BID BULLETIN NO. 5 For LBP-HOBAC-ITB-CW-20180727-01

Construction of LANDBANK Malolos Highway Office

Building

September 27, 2018

ANNEX D-1

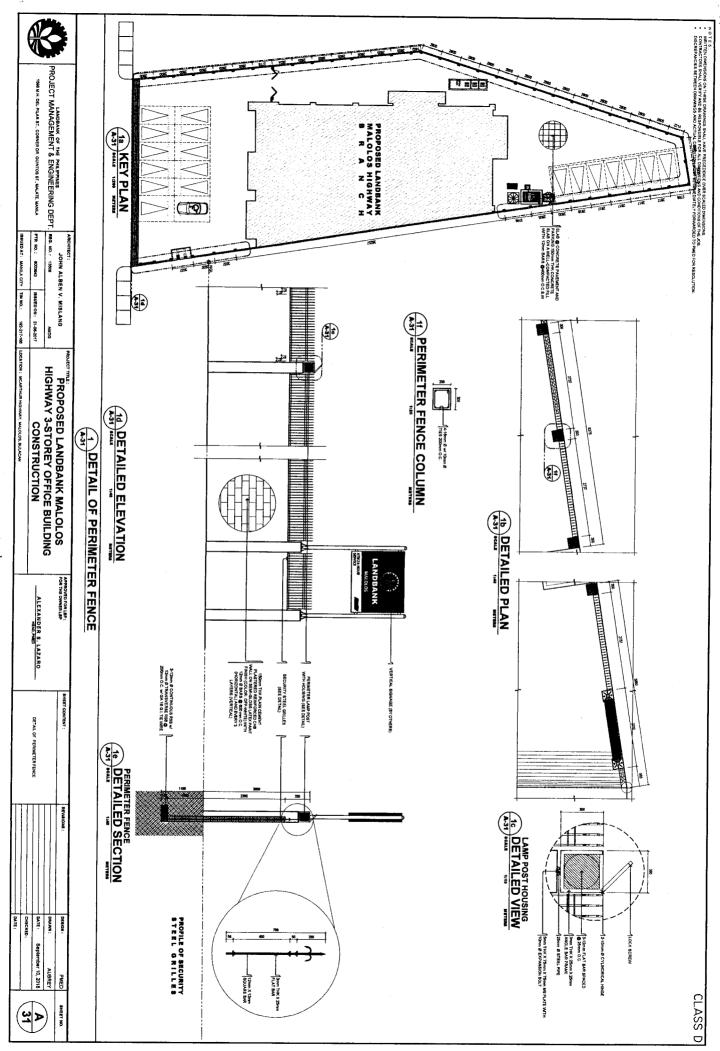
- contract involving construction of a building for a branch of a Bank or any building construction.
- 10) The bidder is requesting for the detailed drawings for the column and spacing of security steel grilles of perimeter fence, concrete pavement (driveway and parking), and main stair (thickness of stairs slab, rebar, etc.)

- 16) The bidder is requesting for the complete details of the micro/bored pile and soil investigation report of the project for costing purposes.

- contracts involving building construction, renovation, or expansion.
- Please see attached Annexes D-1 and D-2.
- The length of the Wheel Stopper is indicated in the Site Development Plan.
- False columns are designed to be CBH-made.
- Steel casing for bored piles is not needed.
- The said items are included in the BOQ - Part I of Site Development/ Site Works under Cleaning, Clearing and Hauling-out Works.

- The Natural Ground Line is the existing ground level at the proposed site. Please refer to the Elevation Plan (Annex D-1) for details.
- The detailed structural drawing provided may be used for the preparation of cost estimates.
